## ORIGINATION FORM

Proposed Revisions to a Standard Plans Index  
(Please provide all information — Incomplete forms will be returned)

Index Number: 515-052

Index Title: Bicycle Pedestrian Railing (Steel)

Sheet Number (s): 8

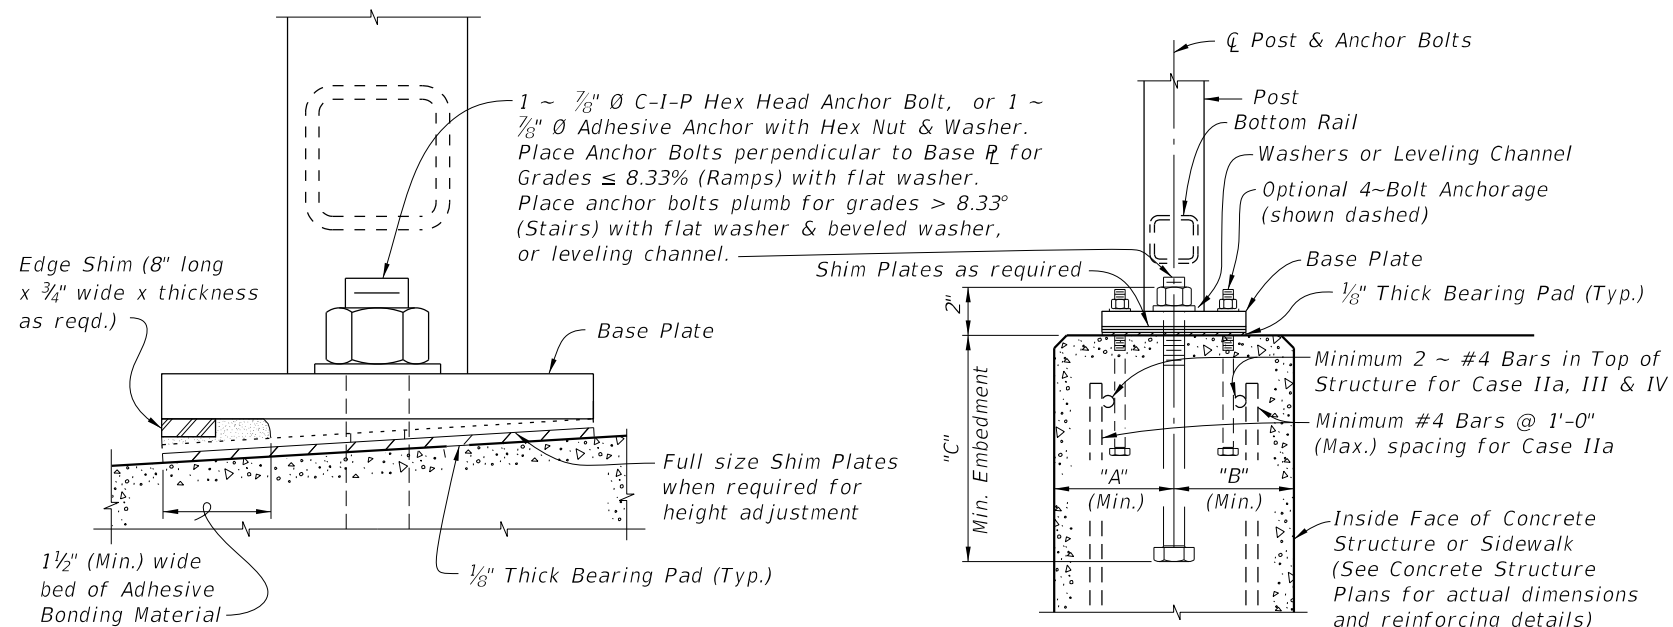
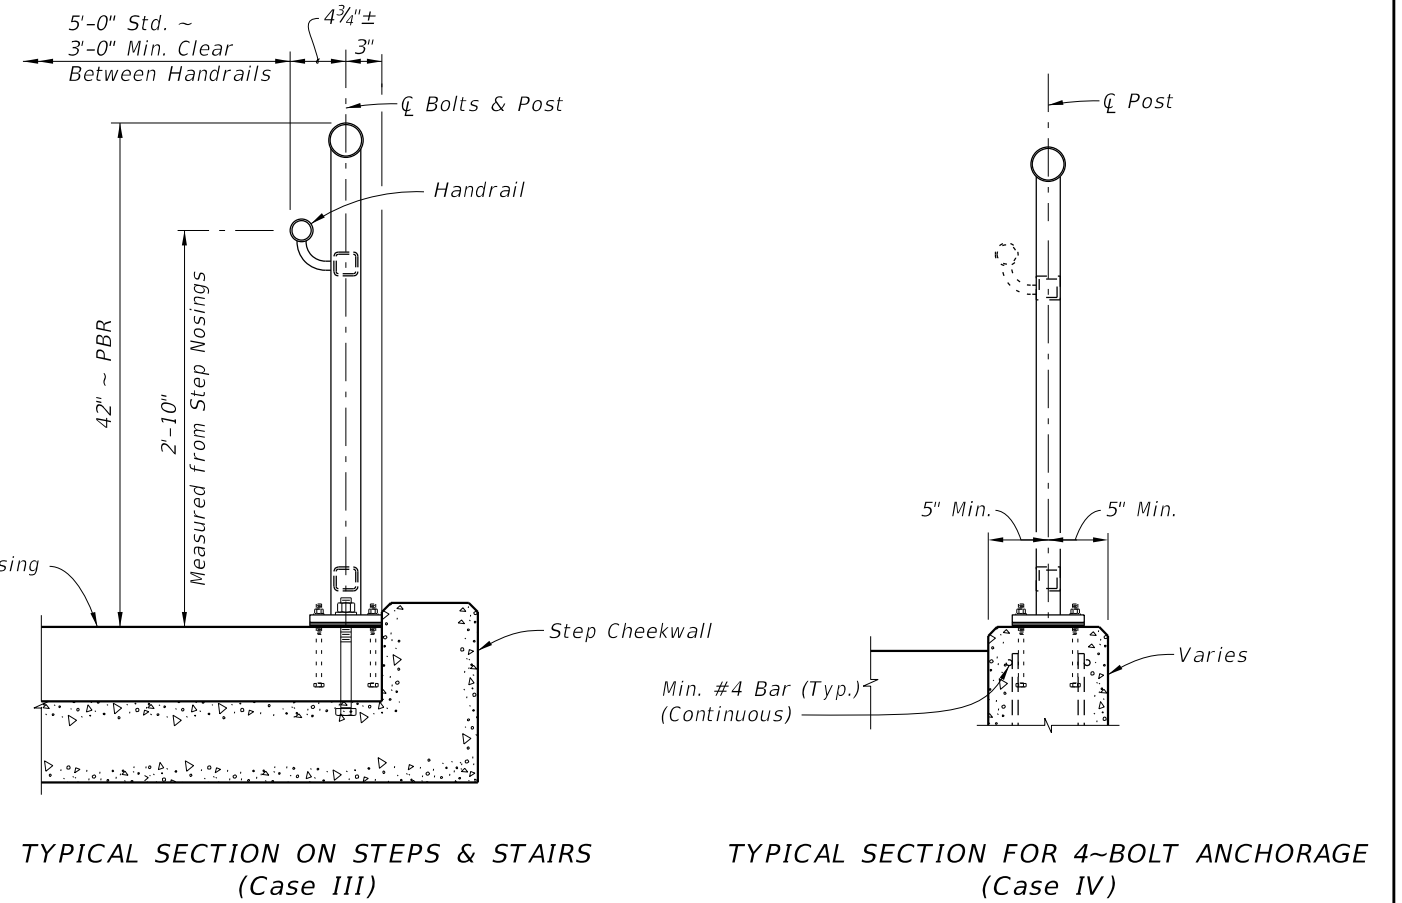
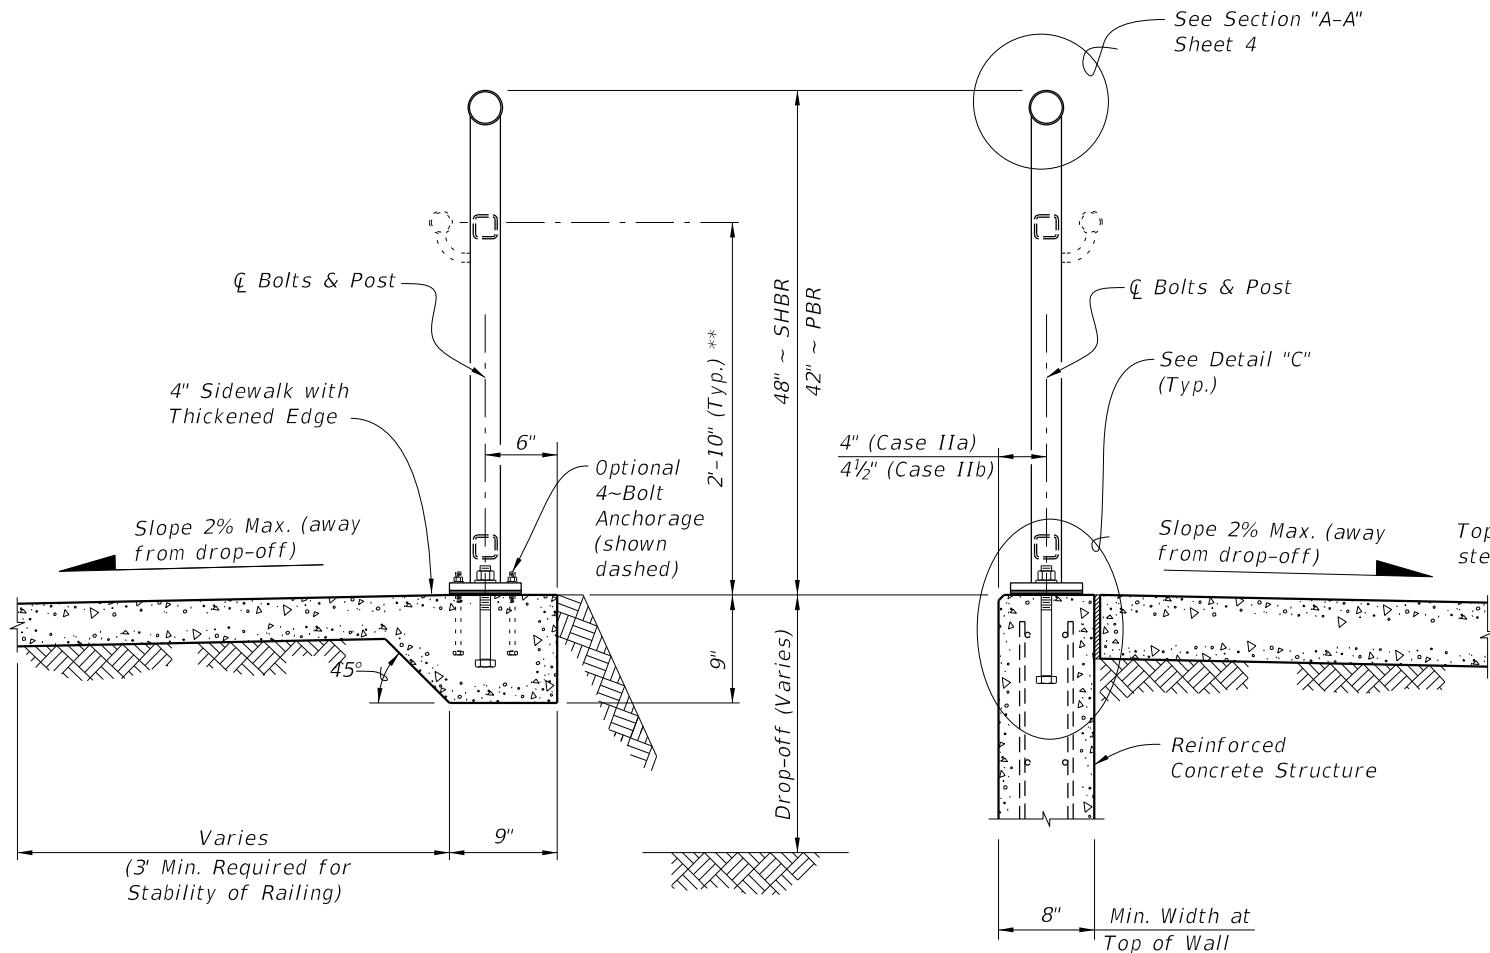
Change edge beam of sidewalk to 9" deep.

Due to research, embedment was reduced to 6"; therefore, the depth can be reduced to 9".
